RAMP REPORT REGION 2 ADA 2026

Route 7 – Vine Street
Belfast

CR09012

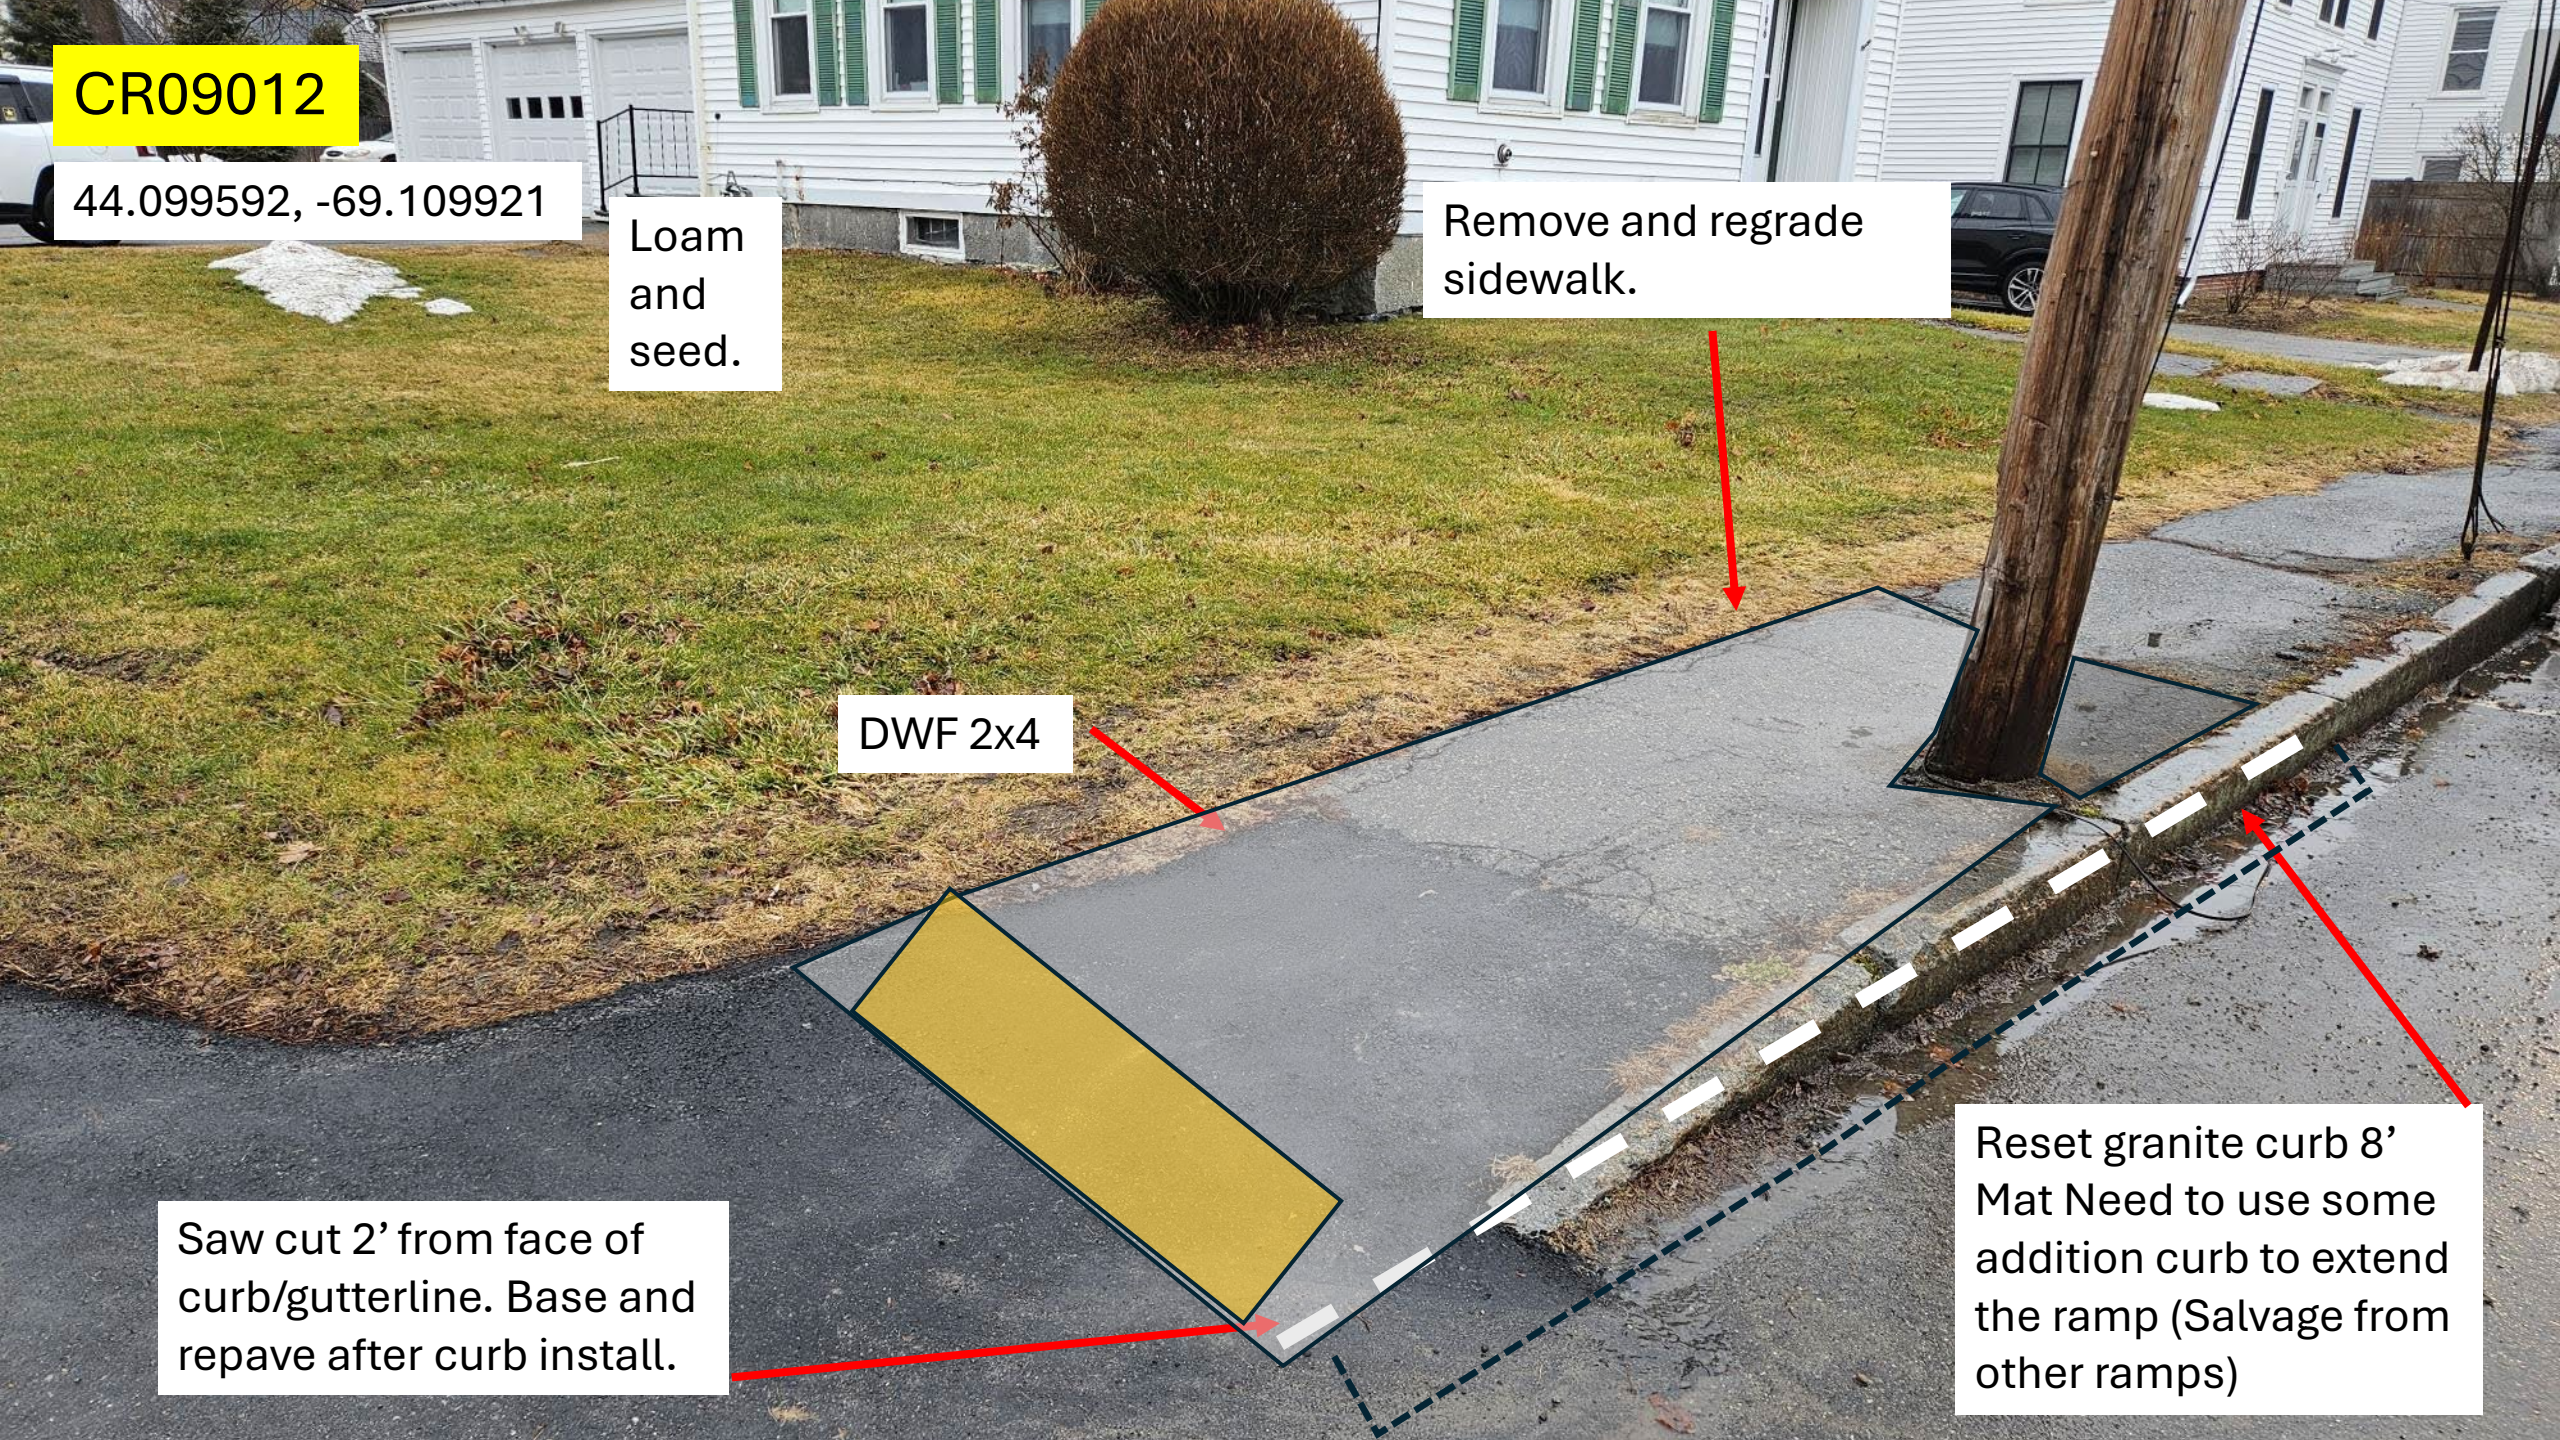
Loam
and
seed.

Remove and regrade
sidewalk.

DWF 2x4

Saw cut 2' from face of
curb/gutterline. Base and
repave after curb install.

Reset granite curb 8'
Mat Need to use some
addition curb to extend
the ramp (Salvage from
other ramps)

CR09016

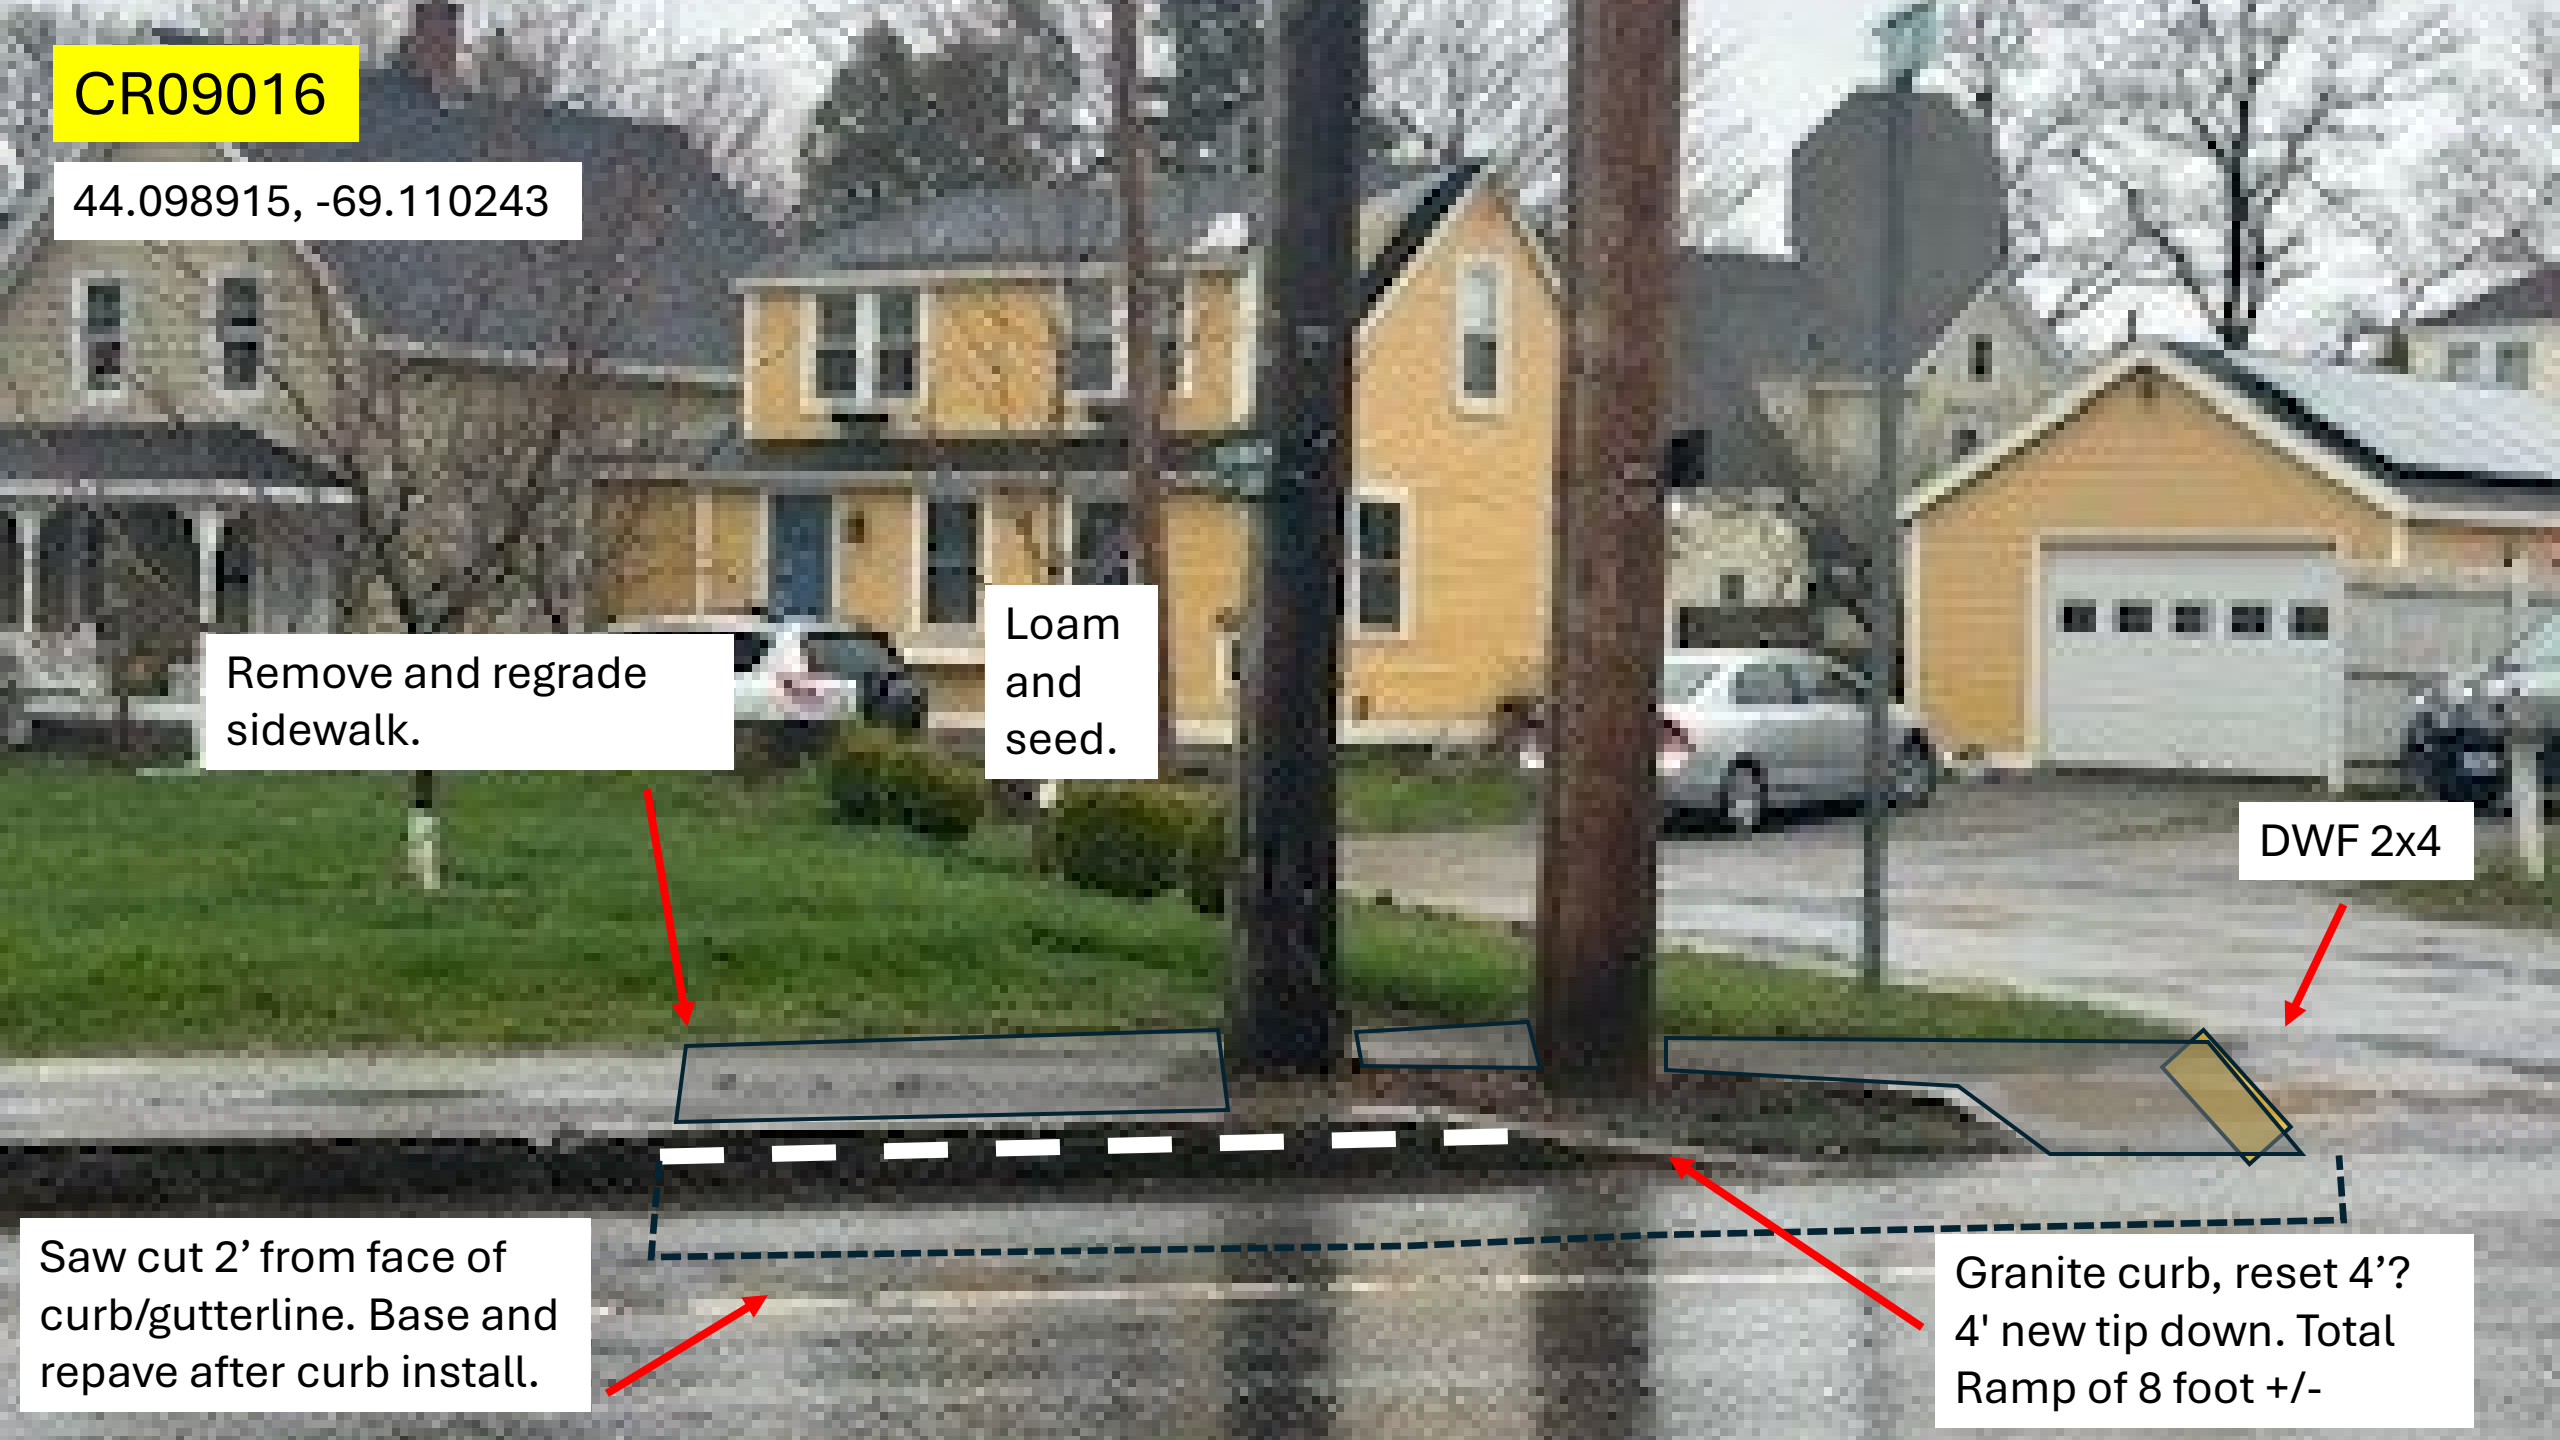
Remove and regrade
sidewalk.

Loam
and
seed.

DWF 2x4

Saw cut 2' from face of
curb/gutterline. Base and
repave after curb install.

Granite curb, reset 4'?
4' new tip down. Total
Ramp of 8 foot +/-

CR09017

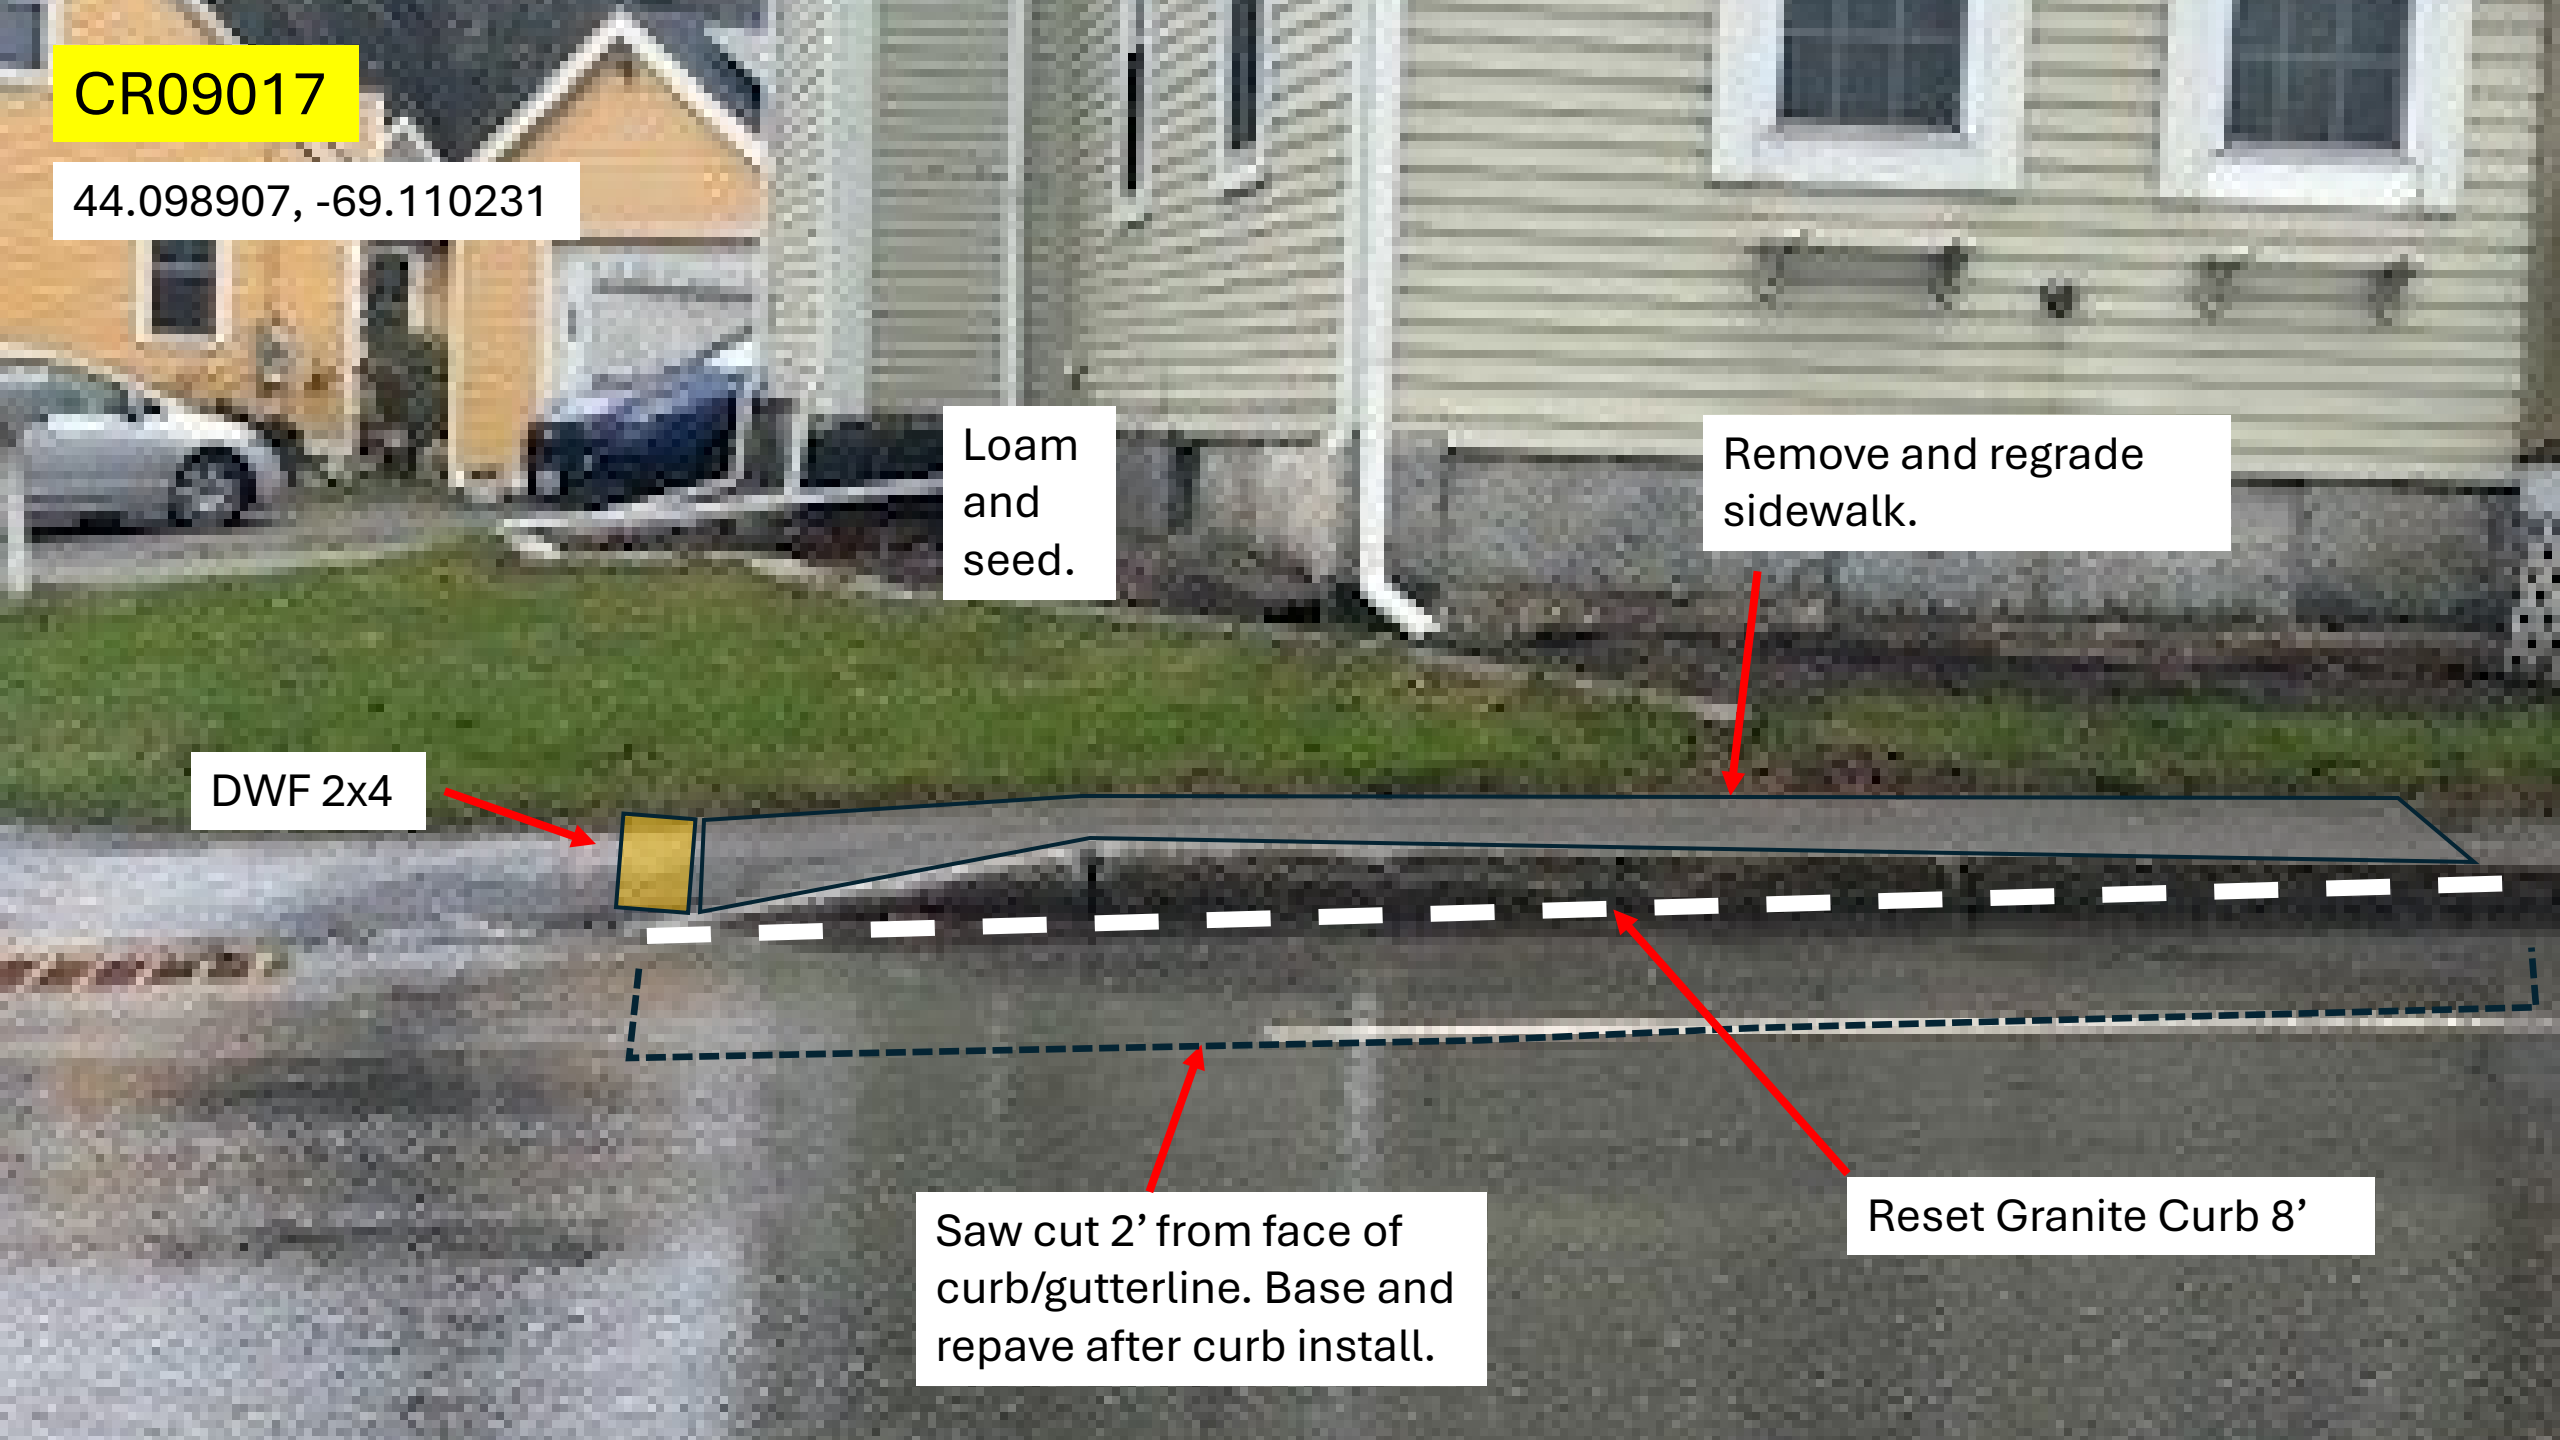
Loam
and
seed.

Remove and regrade
sidewalk.

DWF 2x4

Saw cut 2' from face of
curb/gutterline. Base and
repave after curb install.

Reset Granite Curb 8'
